**HISTORIC LANDMARK COMMISSION**  
**PERMITS IN NATIONAL REGISTER HISTORIC DISTRICTS**  
**OCTOBER 25, 2021**  
**HR-2021-126308**  
**TRAVIS HEIGHTS-FAIRVIEW PARK NATIONAL REGISTER HISTORIC DISTRICT**  
**1505 TRAVIS HEIGHTS BOULEVARD**

Partially demolish contributing residence and construct a second-story addition; convert crawlspace into basement.

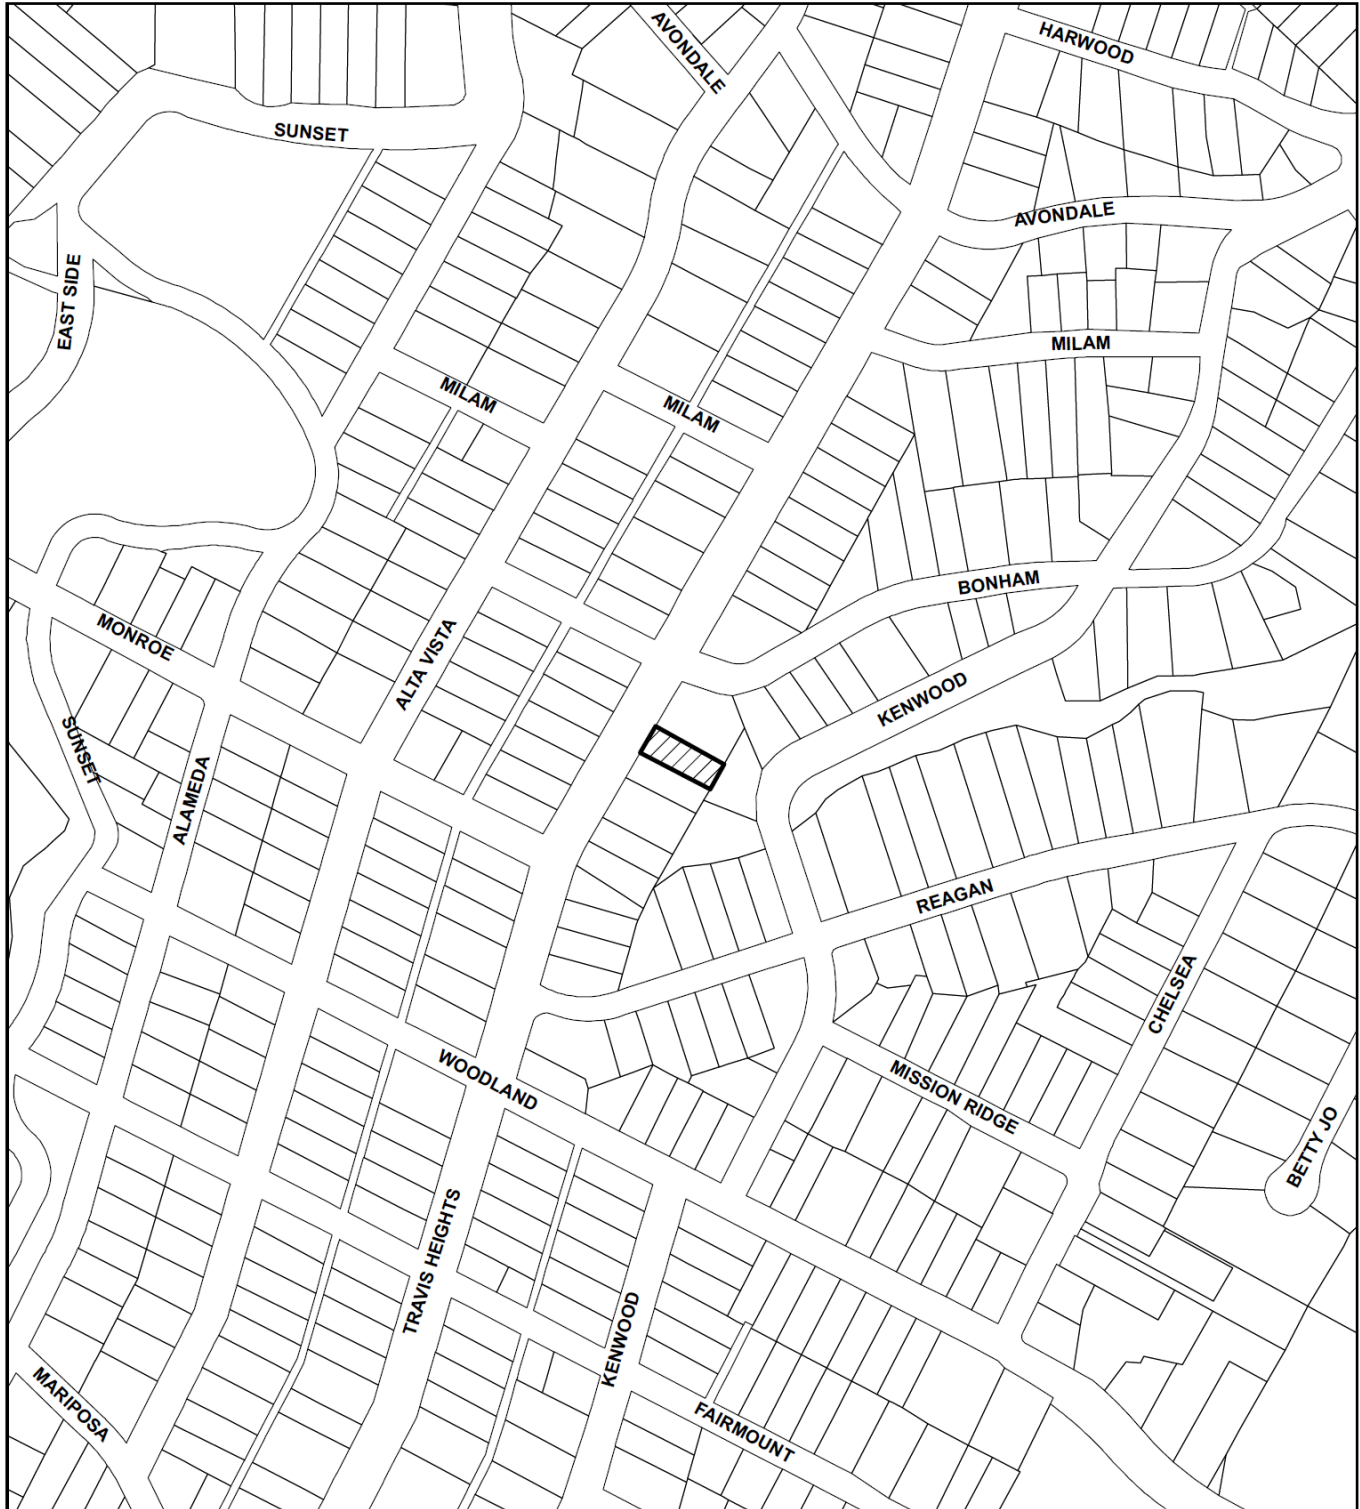
Retain as many character-defining features as possible, including siding, gable vents, wood windows, piers, columns, and railings. Consider alternatives to raised roof ridge. Push back addition as much as possible from front of house.

The applicant has made significant design revisions, including retaining the character-defining features of the front porch, including the original porch gable with brackets and gable vent, box columns and masonry piers, and wood handrails.

Original wood siding will also be retained on the front and sides of the house. The front door and all windows will be replaced but will match the original design on the façade and front 1/3 of the side elevations.
